SUBMISSION

22 February 2023

RE: DA 2023 /0072
100 HILLTOP ROAD, AVALON
WRITTEN SUBMISSION: LETTER OF OBJECTION
SUBMISSION: TULLOCH

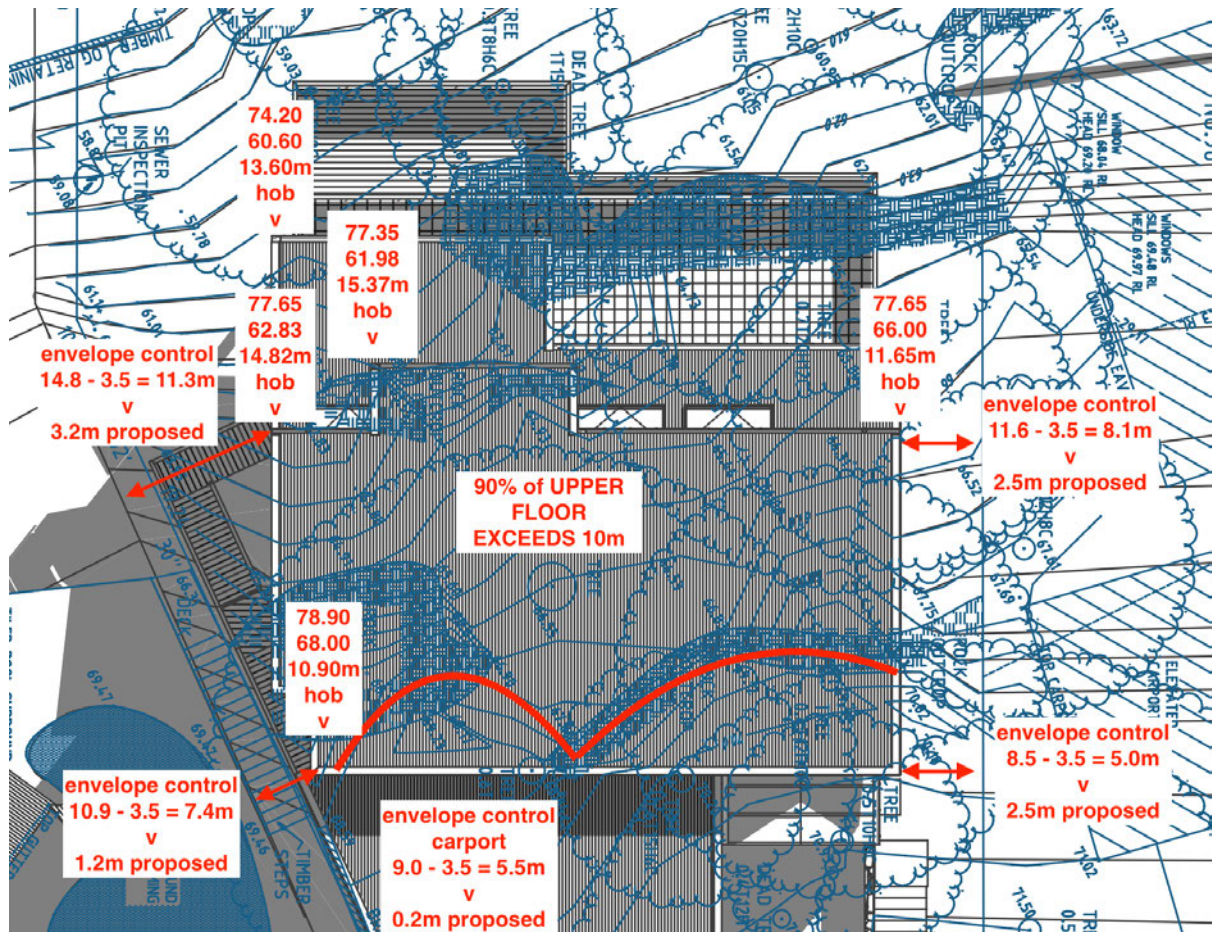
The DA drawings have not adequately transferred the spot levels from the Registered Surveyors drawing onto the DA Architectural drawings to allow assessment of heights.

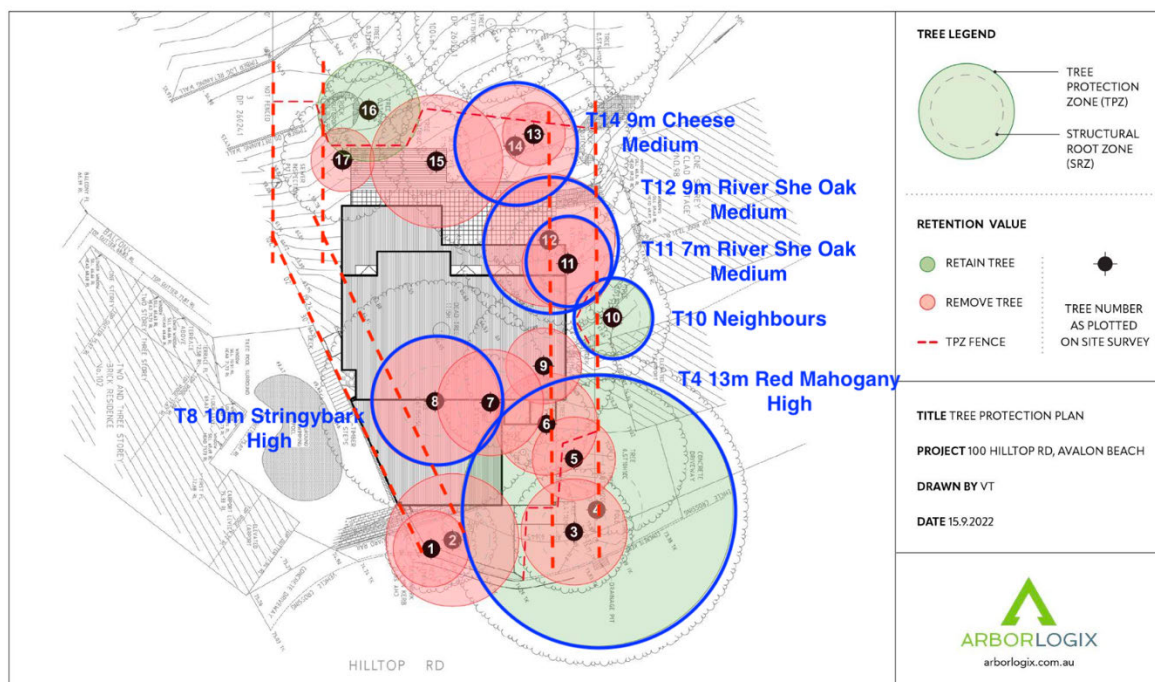
The multiple non-compliances arising from the proposed upper floor levels indicates that the proposed development cannot achieve the underlying objectives of this control, resulting in an unacceptable building bulk when viewed from adjoining and nearby properties.

The development presents an inappropriate response to the site and an unsatisfactory response to the desired future character of the area.

As detailed above, a redesign of the proposed development is strongly recommended to improve the amenity of adjoining properties.

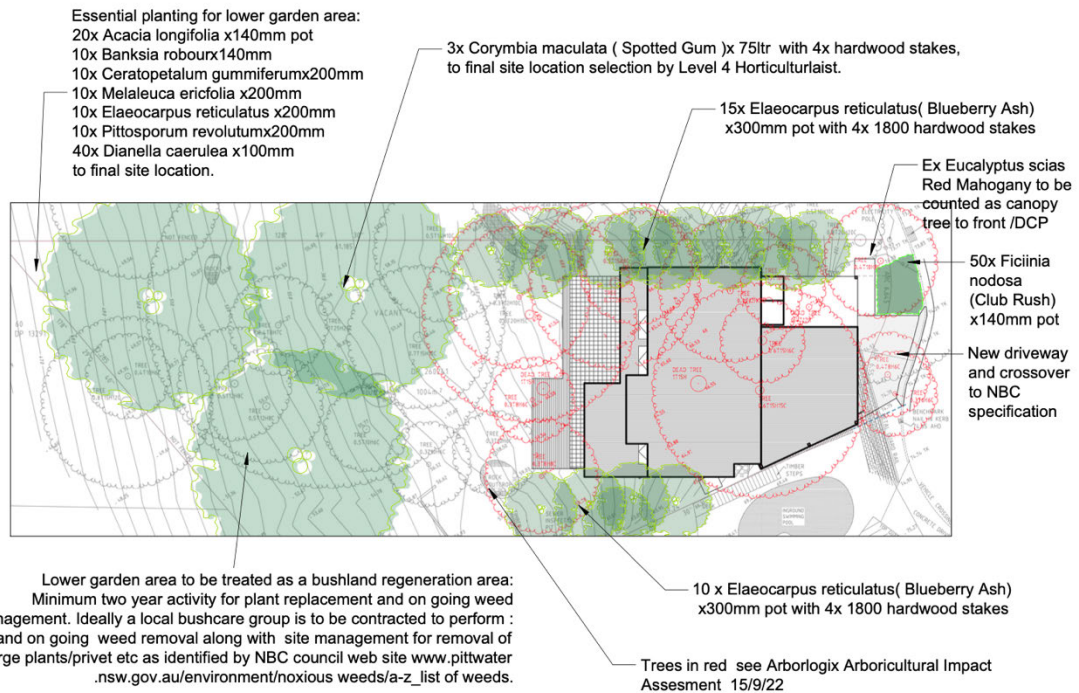
My clients are concerned that new trees are positioned within the Tenacity Viewing Corridors to my clients' view.

I contend that if the existing trees are retained on the site as proposed, the BAL FZ control that "*tree canopy cover should be less than 15% at maturity*", is already exceeded, and therefore all new trees proposed should be deleted from the Landscape Plan.
